ADDENDUM NO. 02 TO THE CONSTRUCTION DOCUMENTS BID PACKAGE

Client: Arrowhead Regional Medical Center

Project: Oncology-Ambulatory Clinic

SHA Project No.: 18242.100

INTERIOR ELEVATIONS & DETAILS

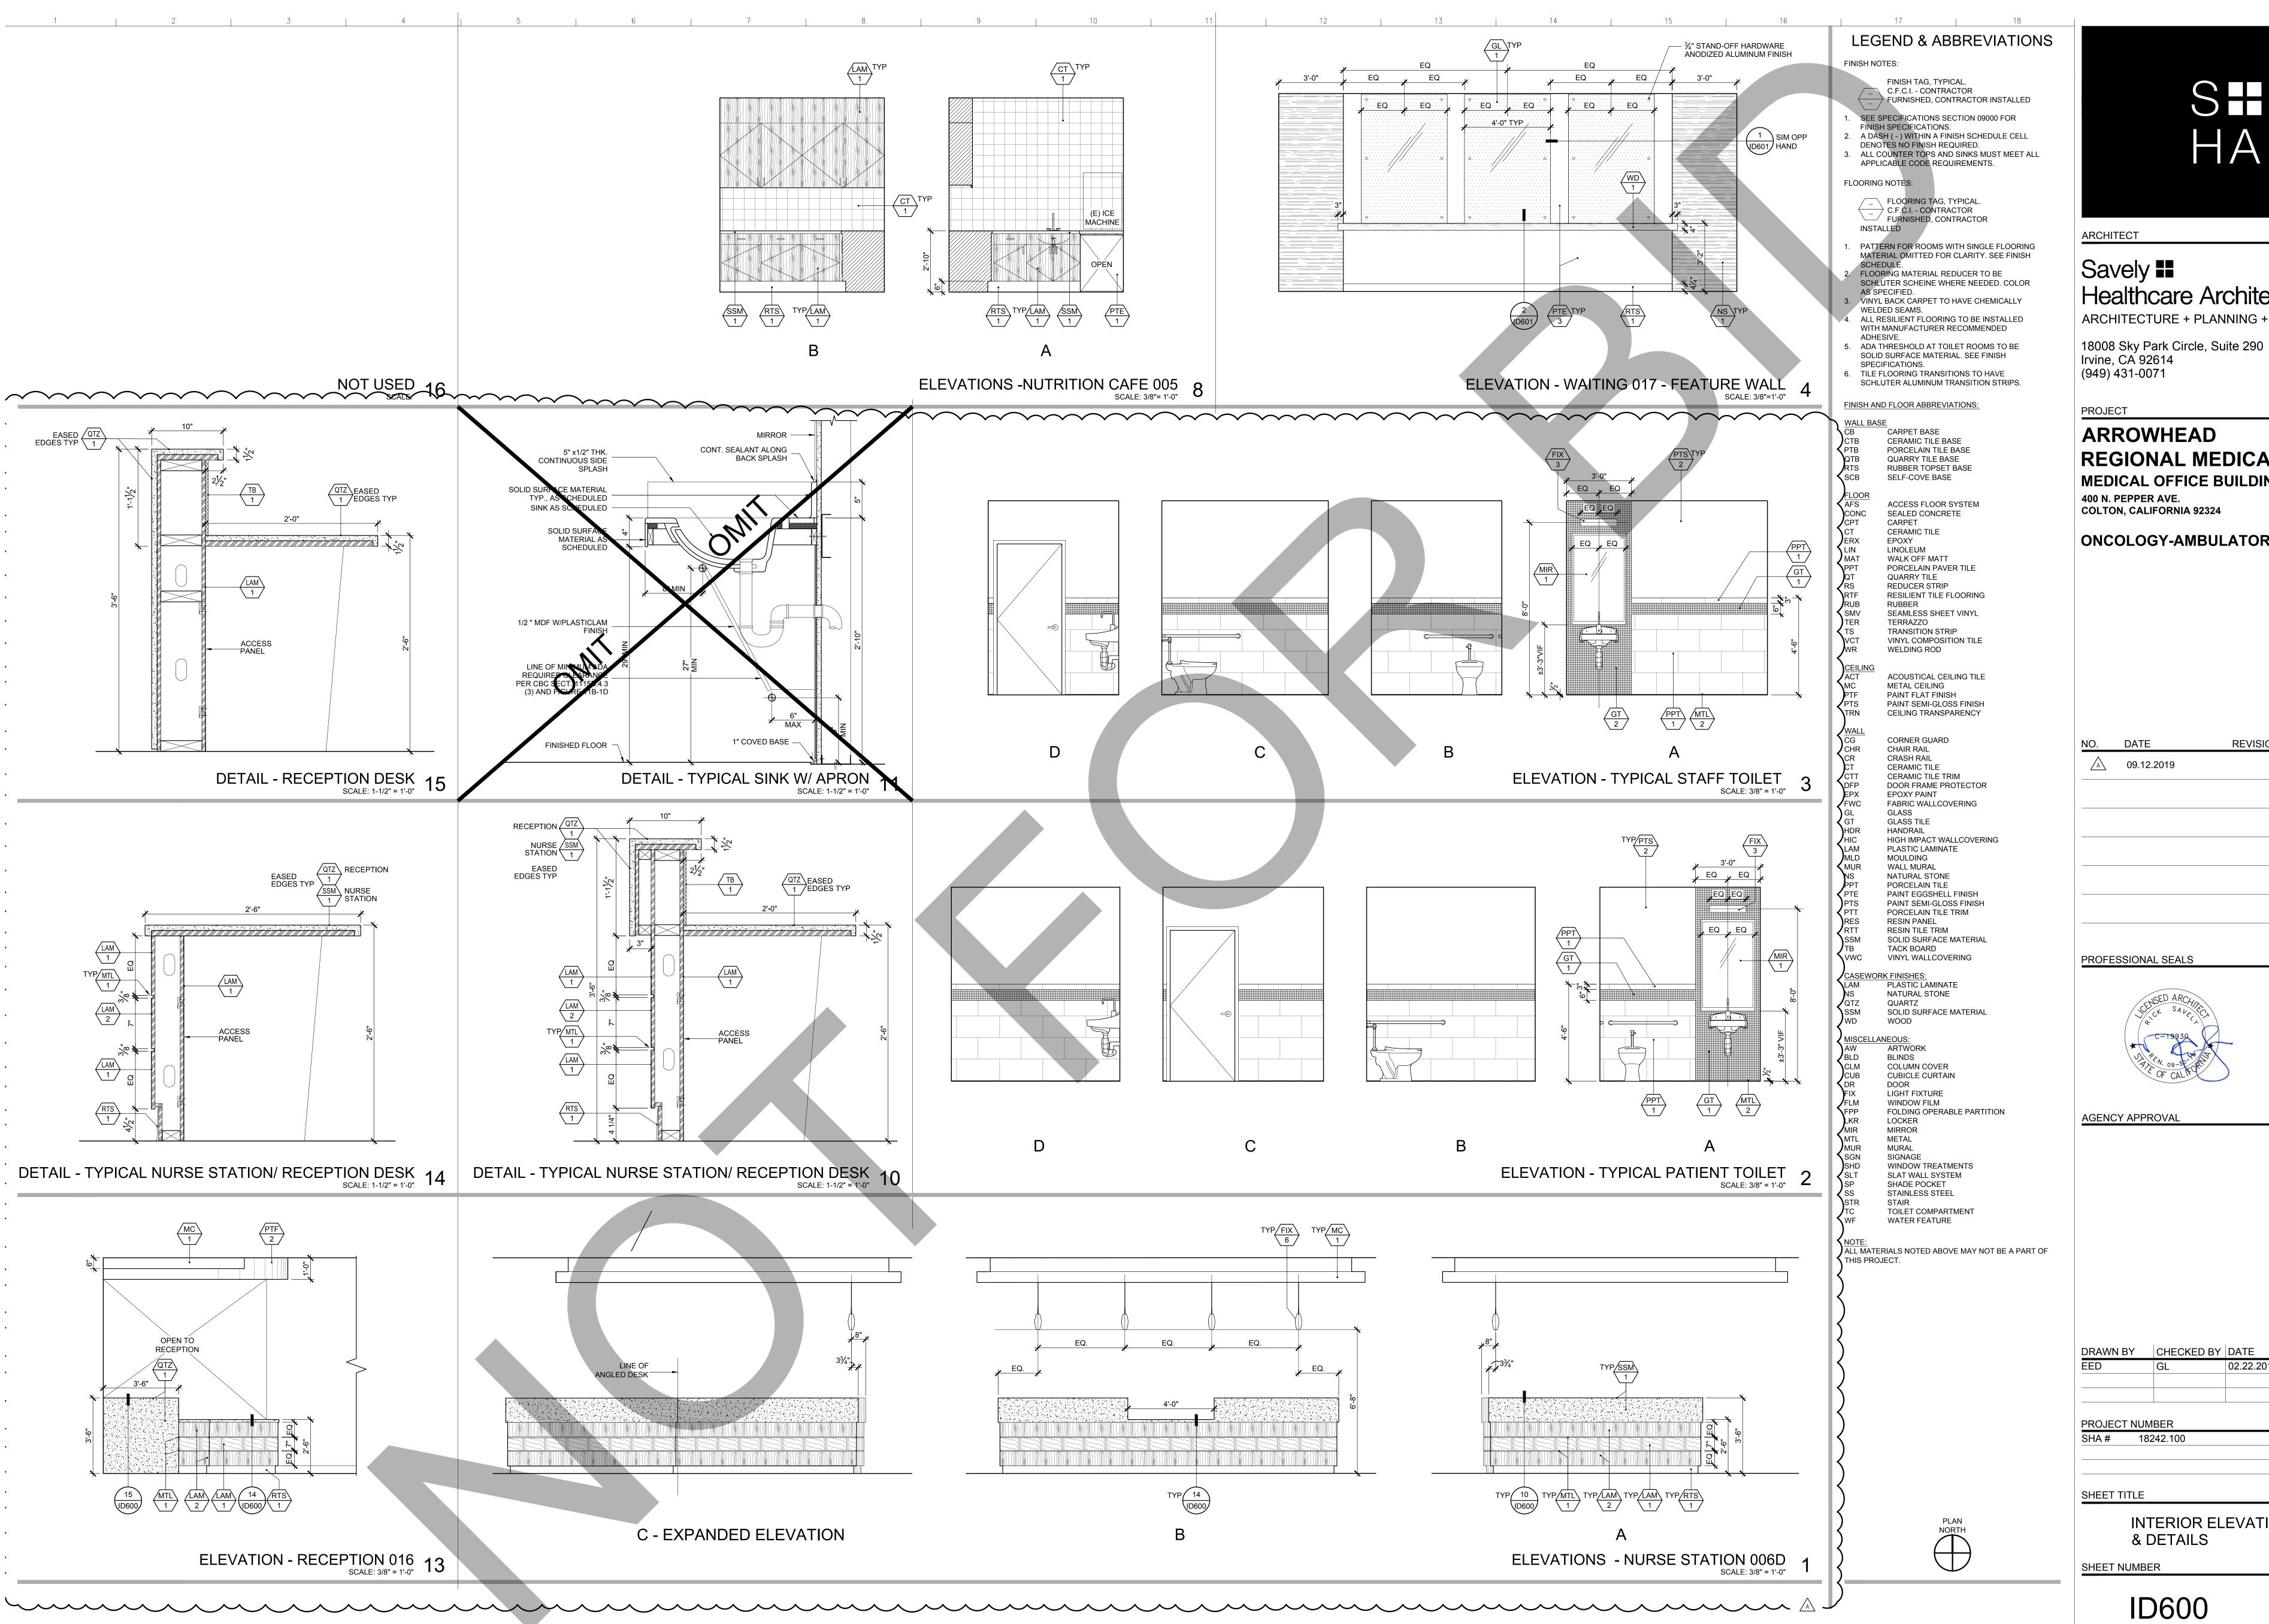
- ID300 Added Note to plan regarding Window Treatments.
- **ID600** Typical Toilet Room Interior Elevations revised to match Architectural drawings.

Detail 11/- omitted from drawings.

Reception and Nurse Station Elevations and Details revised to match Architectural.

003.3	Interior elevations A3, E7 & J7/A204 show wall hung sinks at Patient and Staff Toilet Rooms. Elevations 2 & 3/ID600 & Finish Schedule on ID700 show solid surface countertop with undermount sink at these locations. Please clarify if these sinks are wall or counter mounted.	The sinks shown on the Architectural interior elevations and referenced in this RFI are to be wall hung per the architectural drawings. The Interior Design drawings have been revised, see attached revised ID drawings.
